UNITED STATES PATENT AND TRADEMARK OFFICE

APPLICATION NO.	FILING DATE	FIRST NAMED INVENTOR	ATTORNEY DOCKET NO.	CONFIRMATION NO.
10/808,360	03/25/2004	Samad M. Edlou	1857.0870001	4756
26111	7590	06/09/2006	EXAMINER	
STERNE, KESSLER, GOLDSTEIN & FOX PLLC 1100 NEW YORK AVENUE, N.W. WASHINGTON, DC 20005			LAVARIAS, ARNEL C	
			ART UNIT	PAPER NUMBER
			2872

Office Action Summary

DETAILED ACTION

FIG. 3

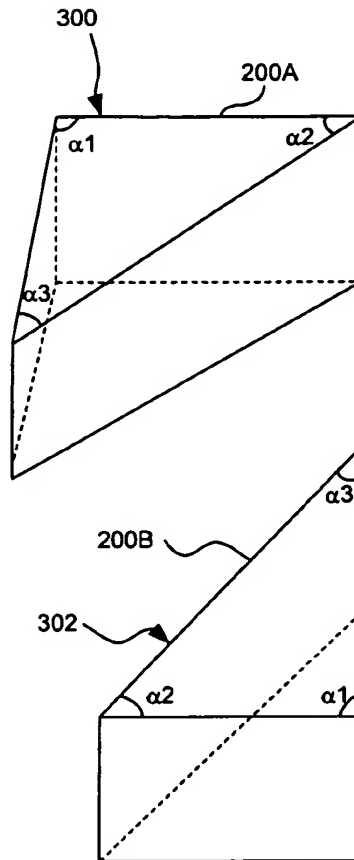
Figure 3- the arrow from reference numeral 300 is pointing to the incorrect surface of prism 200A. This arrow should point to the hypotenuse surface of the prism.
